FINAL INITIAL STUDY

Chick-fil-A

**(GPA 2019-0001 / ZC 2019-0001 / LCPA 2019-0002 / AMEND 2019-0004 /
AMEND 2021-0011 / CDP 2019-0007)**

October 2021

Exhibit 2-3

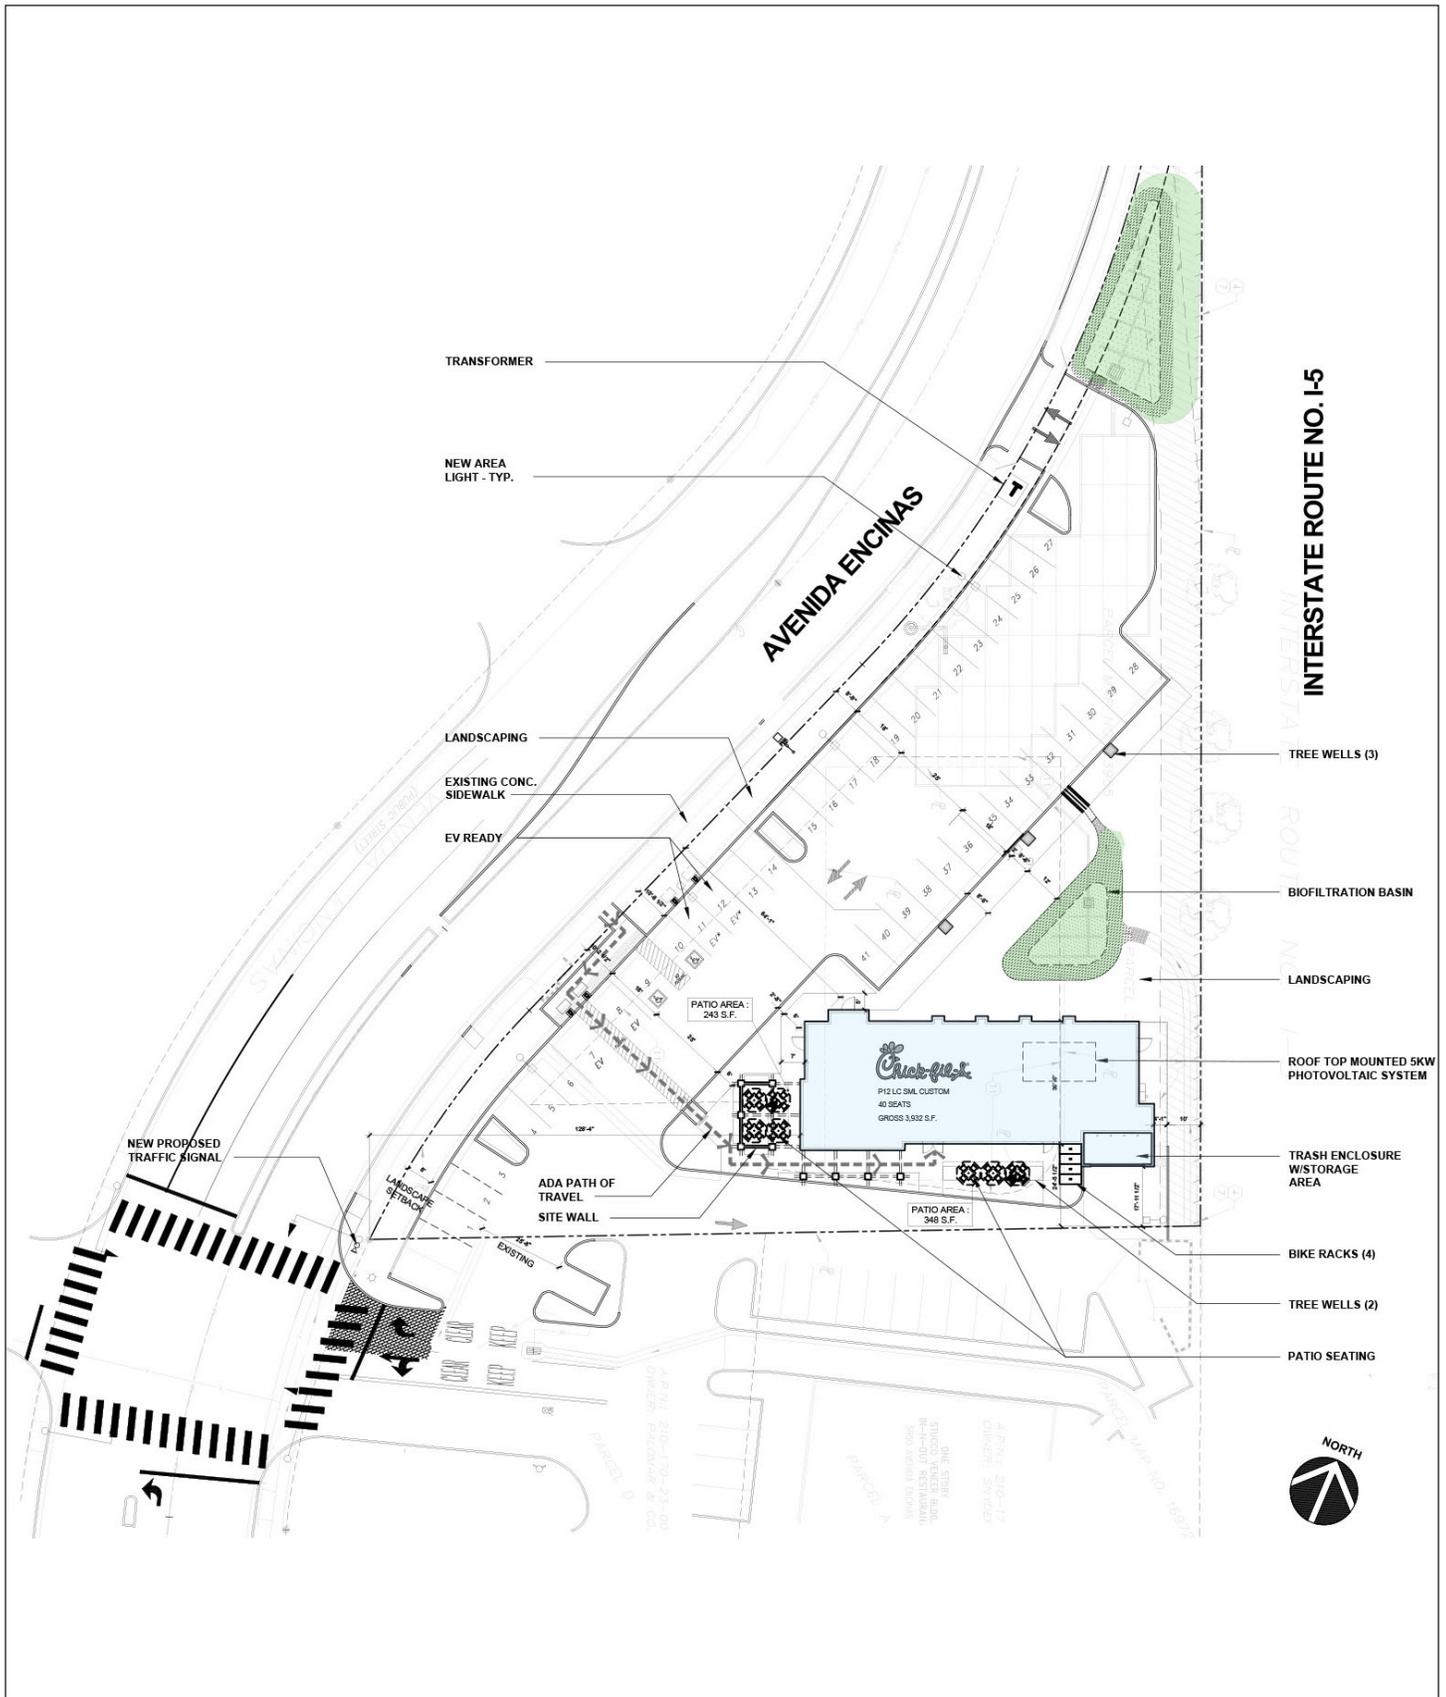
- Future "Caltrans Temporary Construction Easement" area is correctly identified on Exhibit 2-3 (Conceptual Site Plan). Two doors on the east side of the main building might not be usable when the easement area is in use during construction.

- 2-2 The commenter confirms that Draft IS/MND Exhibit 2-3, *Conceptual Site Plan*, correctly identifies the “Caltrans Temporary Construction Easement” along the eastern project boundary and states that access to the proposed restaurant building from the eastern entrance may be blocked when the easement area is in use during Caltrans-related construction. As such, the proposed project has been slightly modified to accommodate access given the easement area. Refer to Section 2.0, Revisions to Information presented in the Draft IS/MND. Per these minor project modifications, the proposed building has been shifted to accommodate the door outside of the easement.
